**CVL Network – Network Code Condition G1 Network Change Proposal:
Cardiff Bay Station Platform Changes and Cardiff Bay Platform 2 Buffer Stop**

Appendix A – Proposed Scheme for the Installation of the Buffer Stop at Cardiff Bay Station, Platform 2

Appendix B – Proposed Scheme for Change to Operational Platform Length at Cardiff Bay Station.

Annex 1 - Friction Element Buffer Stop type 4 ZEB/5

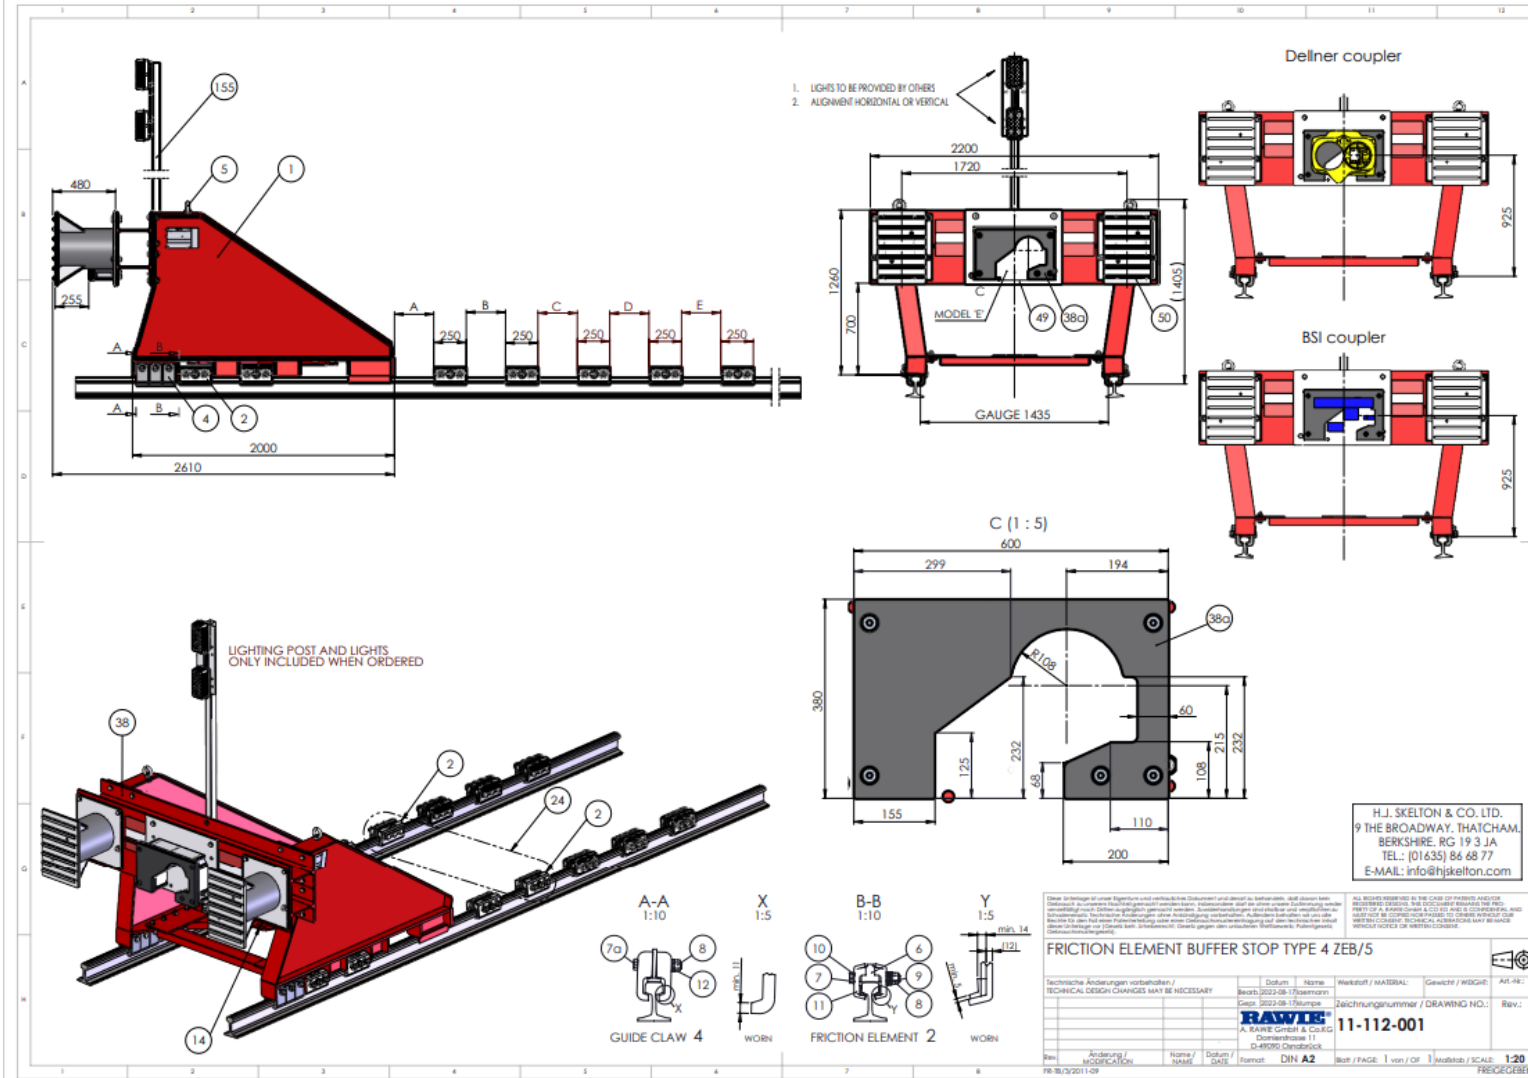
Platform 2 will be equipped with a Friction Element Buffer Stop type 4 ZEB/5 (illustrated in Annex 1)

Platform 1 at Cardiff Bay will be closed until further notice, and a new platform (platform 2) will be opened, equipped with a Friction Element Buffer Stop type 4 ZEB/5 (illustrated in Annex 1).
